APPARATUS AFFECTED: DATASPEED 40 Pedestals 40CAB901/AA, 40CAB901/AB, 40CAB901/AF, 40CAB901/AG and 40CAB901/AJ.

PART AFFECTED: TP401673 Switch

Appendix 1, Section 579-505-350, Issue 1
Teletypewriter Change Notice
TCN 2201 Issue 1
March, 1976

Attached Sheet 1

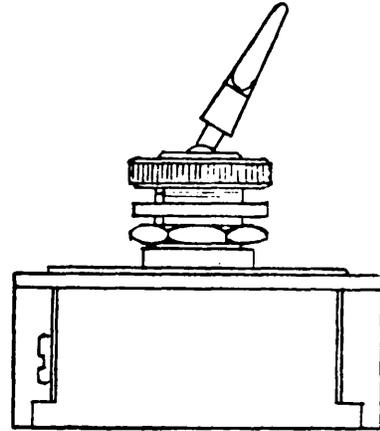
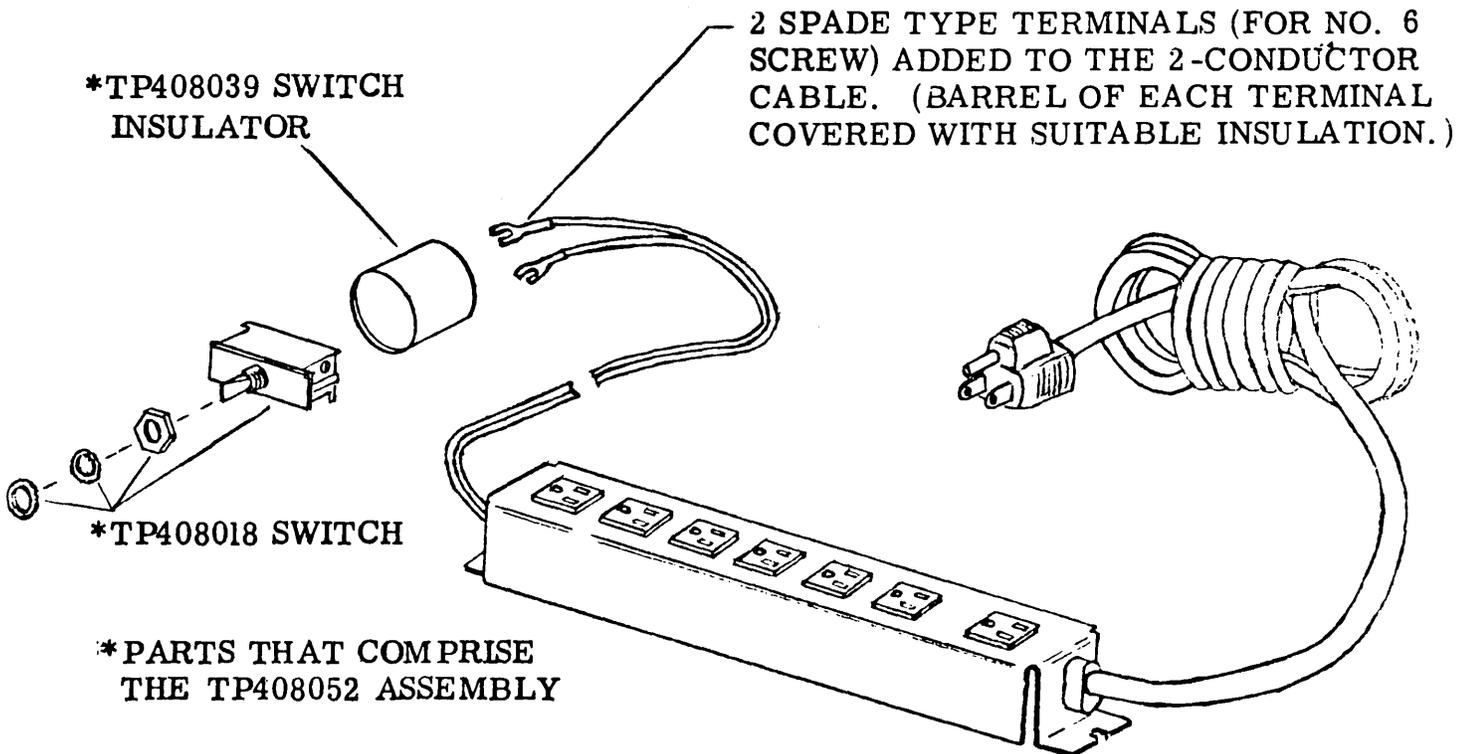
The TP401673 switch (15 amp - 125 VAC) is replaced by a TP408018 switch (16 amp - 125 VAC).

Two TP320410 spade type terminals are added to the 2 - conductor cable to enable connection to screw terminals on the TP408018 switch (new). The barrel of each terminal is covered with suitable insulation.

A TP408039 switch insulator is added. After connection of the 2 - conductor cable to the switch, the TP408039 insulator is installed on the TP408018 switch to cover exposed portions of the switch screw terminals.

IDENTIFICATION: The TP401673 switch (old) has solder terminals. The TP408018 switch (new) has screw terminals.

On the old-style TP401665 ac distribution panel assembly, the wires of the 2 - conductor cable are soldered to the terminals on the TP401673 switch (old).

On the new-style TP401665 ac distribution panel assembly, the wires of the 2 - conductor cable have spade type terminals and are connected to screw terminals on the TP408018 switch (new). The screw terminals on the wired switch are covered with electrical tape or the TP408039 switch insulator (rubber tube).

NOTE: THE SCREW TERMINALS ON THE TP408018 SWITCH (NEW) MUST BE COVERED WITH A TP408039 SWITCH INSULATOR OR WITH TWO OR MORE THICKNESSES OF ELECTRICAL TAPE AFTER CONNECTION OF CABLE.

2 SPADE TYPE TERMINALS (FOR NO. 6 SCREW) ADDED TO THE 2-CONDUCTOR CABLE. (BARREL OF EACH TERMINAL COVERED WITH SUITABLE INSULATION.)
